TO: ALL REGENCY COMMUNICATIONS PROFESSIONAL SALES AND SERVICE CENTERS
ALL REGENCY COMMUNICATIONS PROFESSIONAL SALES REPRESENTATIVES

MODELS AFFECTED: MCE21/24, MCU31/34, MCBU19/35 - ALL IF AN OPTION
IS CONNECTED TO C5 OR C6

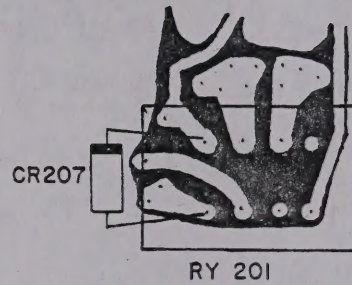
SYMPTOM: Option fails without apparent cause.

Add relay clamping diode, IN4148, Regency P/N 4805-1241-200.

a. MCU31/34, MCBU19/35

Add CR304 as shown below.

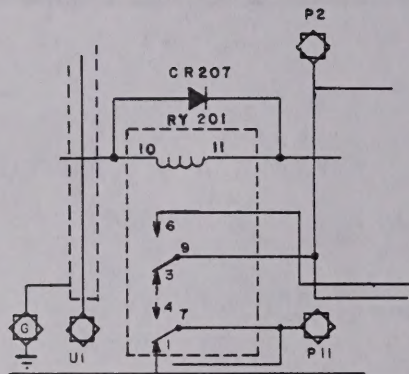
b. MCE21/24

Add CR307 as shown below.
